## DSA CODE AMENDMENT DEVELOPMENT

Tracking		Applicable Code	
Date Received:	-	Applicable Code Section(s):	CBC Ch. 1, Sect. 1.9.1.1.3
DSA Tracking Number:	ITEM 1.01	Topic:	Public housing
Date Reviewed:	05/18/2018		
Status:	CAC Submittal

### Current Code Language

**FIGURE 11B-813.2.1.2**  
**CLEARANCE AROUND ADULT CHANGING TABLE**

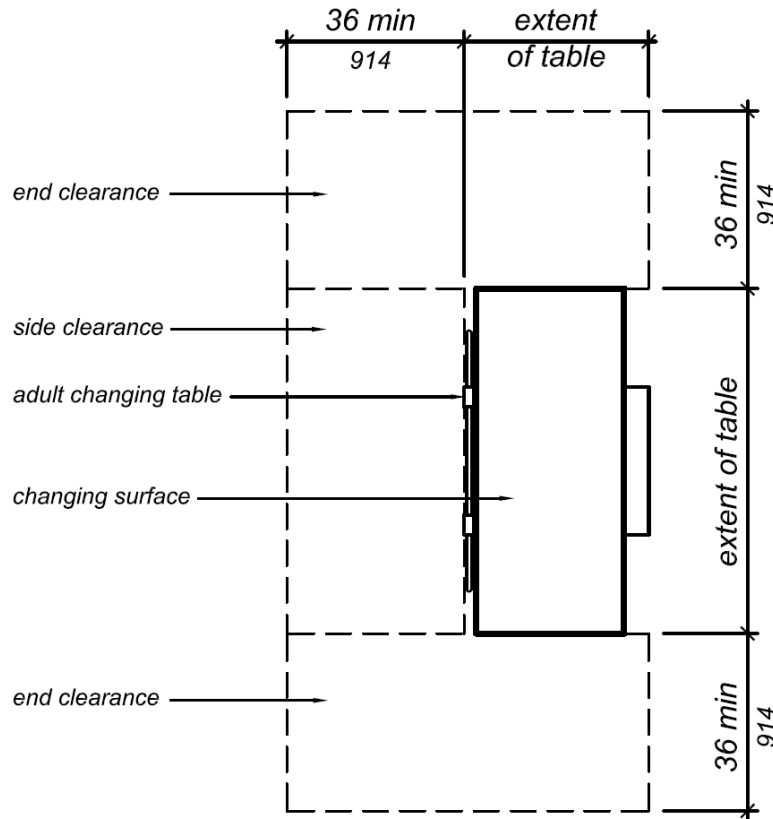
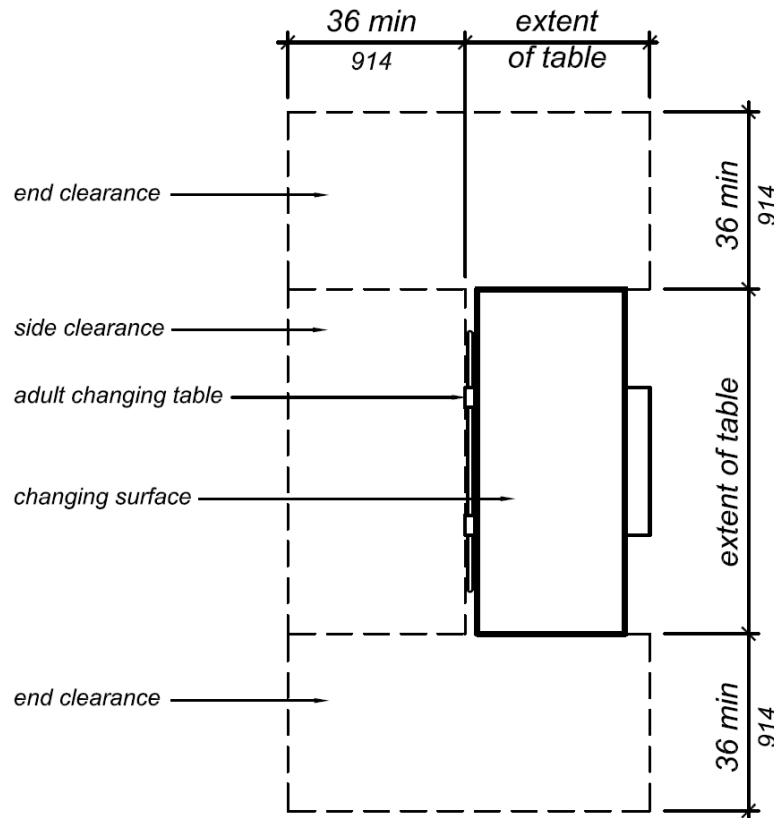
DSA-AC is proposing new definitions, scoping and technical accessibility code requirements for adult changing facilities in response to Assembly Bill 662 (2015-2016) / California Health & Safety Code §19952.5. Consistent with statute, this proposal requires an adult changing facility at newly constructed commercial places of public amusement, as defined. This proposal also provides specific requirements for other adult changing facilities that are optionally provided. DSA convened an Adult Changing Facility Task Force which met five times in 2017 to solicit input on the scoping and technical requirements for these facilities.

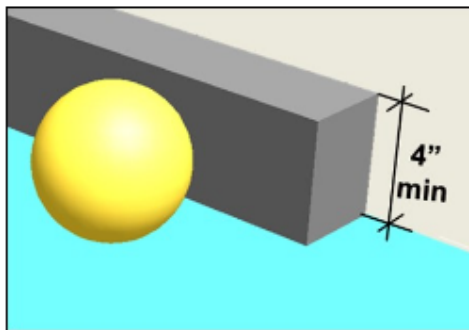
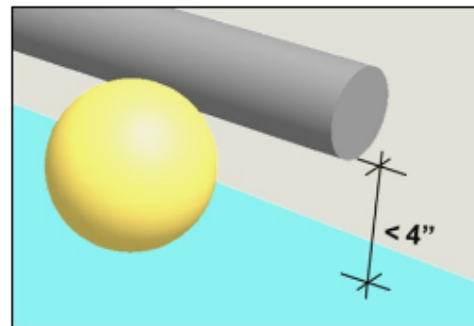
don't comply with the 2010 ADAS which require a curb or barrier which prevents a 4 inches diameter sphere from passing within 4 inches of the ramp surface. While it is possible to combine a 2 inches high curb with other elements such as a rail to comply prevent the 4 inch diameter sphere from passing within 4 inches of the ramp surface, some may interpret the current language to allow a 2 inches high curb without other elements being provided in combination. This interpretation is inaccurate; a 4 inches high curb without other elements being provided in combination would be required to prevent a 4 inches diameter sphere from passing within 4 inches of the ramp surface. DSA-AC is proposing to amend the first sentence in this section to be consistent with 2010 ADAS 405.9.2 for greater clarity.

- 2010 ADA Standards:  
**405.9.2 Curb or Barrier.** A curb or barrier shall be provided that prevents the passage of a 4 inch (100 mm) diameter sphere, where any portion of the sphere is within 4 inches (100 mm) of the finish floor or ground surface.
- From US Access Board's *Guide to the ADA Standards*:

**11B-405.9.2 Curb or barrier.** A curb or barrier shall be provided that prevents the passage of a 4 inch (102 mm) diameter sphere, where any portion of the sphere is within 4 inches (102 mm) of the finish floor or ground surface. *To prevent wheel entrapment, the curb or barrier shall provide a continuous and uninterrupted barrier along the length of the ramp.*

**FIGURE 11B-604.8.1.2  
MANEUVERING SPACE WITH SIDE-OPENING DOOR**

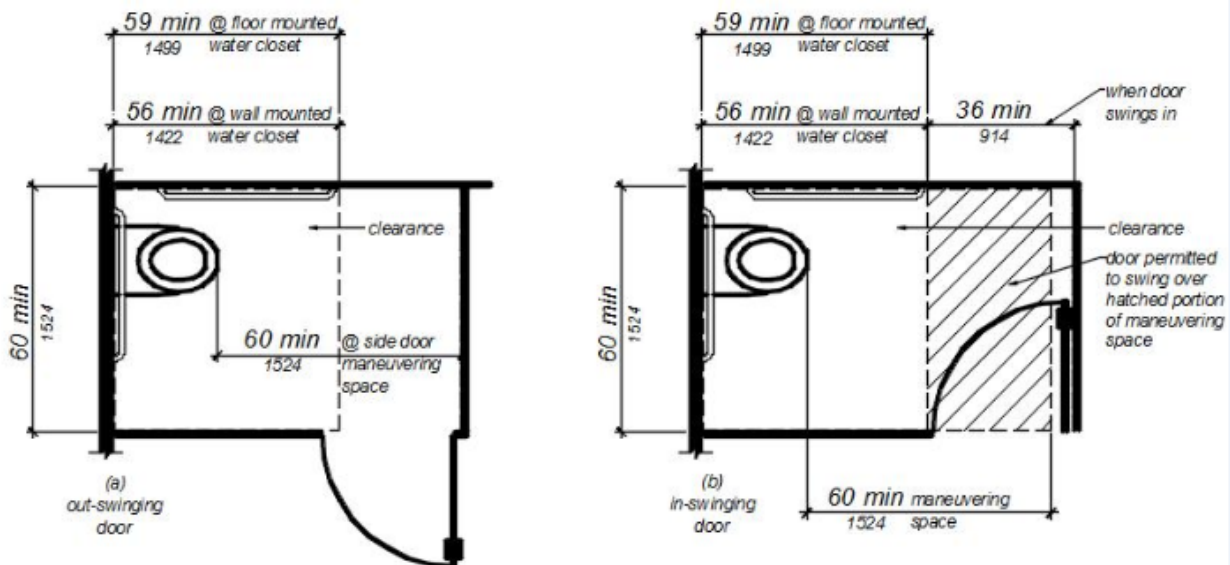
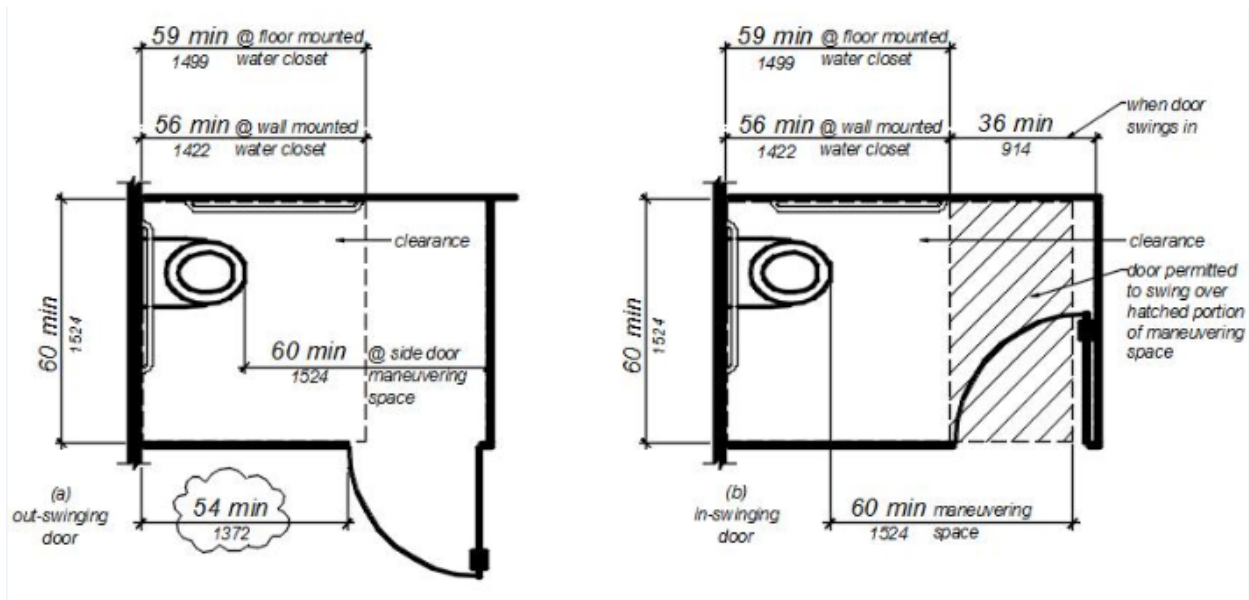
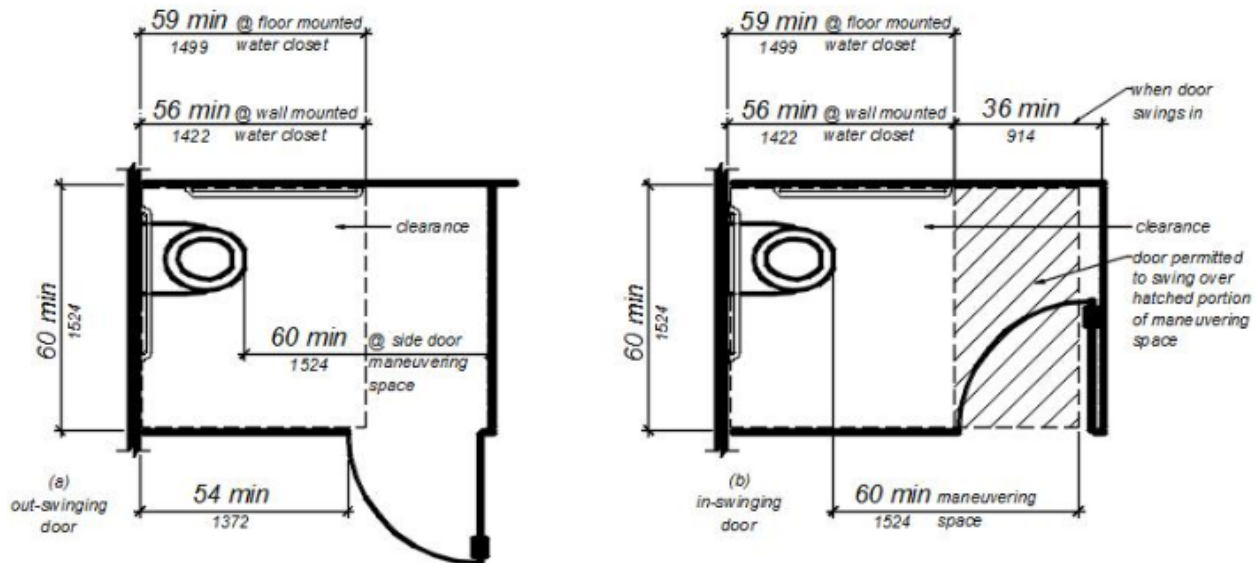
DSA-AC is proposing to amend Section 11B-604.8.1.2 and Figure 11B-604.8.1.2 to revise the required location for out-swinging toilet compartment doors in the side wall or partition of an accessible toilet compartment. The current provisions require the door to be 4 inches maximum from the front partition. This proposal allows the toilet compartment door to be located in a variety of locations in the side wall or partition while maintaining equal or greater accessibility than the current CBC Chapter 11B requirements and the 2010 ADA Standards for Accessible design.

**FIGURE 11B-608.2.1 TRANSFER TYPE SHOWER COMPARTMENT SIZE AND CLEARANCE**

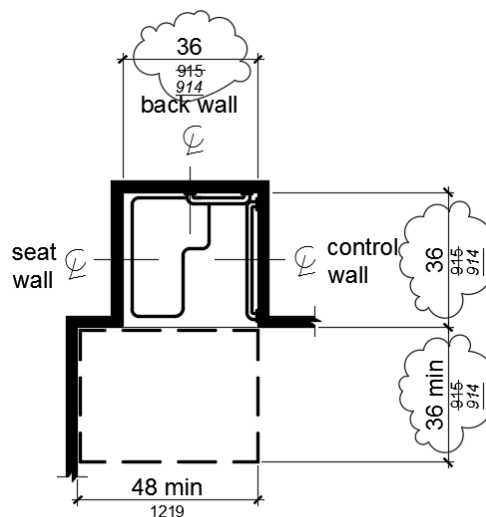
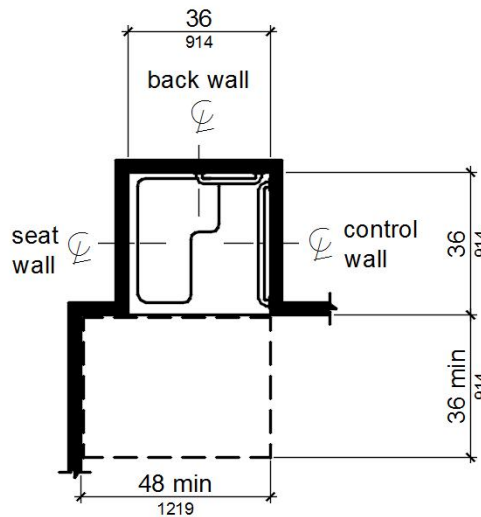
DSA is proposing this code change in response to users of mobility devices who prefer this type of shower stall. By not allowing the use of a transfer shower, in facilities regulated by Chapter 11B, persons with disabilities are denied an option that may better meet their needs. The transfer type shower stall allows for the mobility device to be placed outside of the wet area while using the shower compartment and provides for controls that are within reach range when seated. This amendment, if approved, will align the provisions for a transfer type shower compartment in Chapter 11B with the 2010 ADAS.

**11B-608.2.1 Transfer Type Shower Compartments.** Transfer type shower compartments shall be 36 inches (914 mm) by 36 inches (914 mm) clear inside dimensions measured at the center points of opposing sides and shall have a 36 inch (914 mm) wide minimum entry on the face of the shower compartment. Clearance of 36 inches (914 mm) wide minimum by 48 inches (1219 mm) long minimum measured from the control wall shall be provided.

**FIGURE 11B-608.3.1 GRAB BARS FOR TRANSFER TYPE SHOWERS**

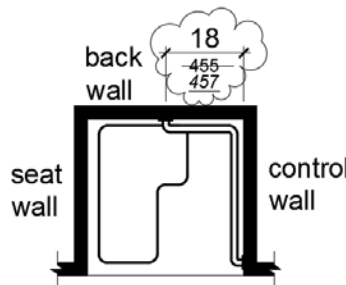
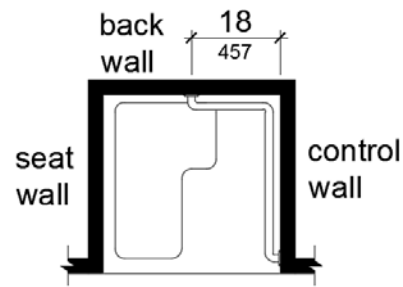
DSA is proposing this code change as a related amendment to Section 11B-608.2.1 to address the requirements for grab bars in transfer type showers.

**11B-608.3.1 Transfer Type Shower Compartments.** In transfer type compartments, grab bars shall be provided across the control wall and back wall to a point 18 inches (457 mm) from the control wall.

**FIGURE 11B-608.5.1 TRANSFER TYPE  
SHOWER COMPARTMENT CONTROL LOCATION**

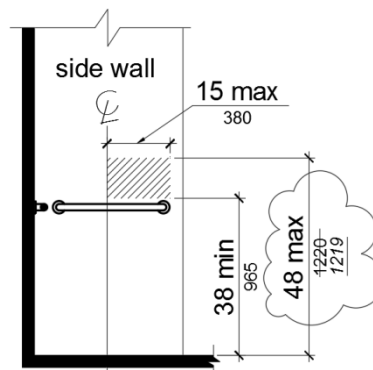
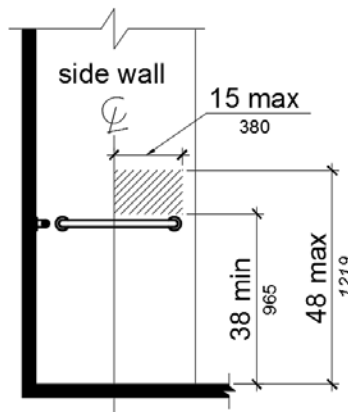
- The first amendment addresses controls that are a single lever design. Other types of controls such as a push button could meet the requirements for operable parts that are referenced to Section 11B-309.4. Therefore DSA is proposing to repeal the requirement that controls shall be a single lever design.
- The second amendment DSA is proposing is related the code change proposal in Section 11B-608.2.1 to provide the requirements for controls in transfer type showers.

**11B-608.5.1 Transfer Type Shower Compartments.** In transfer type shower compartments, the controls, faucets, and shower spray unit shall be installed on the side wall opposite the seat 38 inches (965 mm) minimum and 48 inches (1219 mm) maximum above the shower floor and shall be located on the control wall 15 inches (380 mm) maximum from the centerline of the seat toward the shower opening.
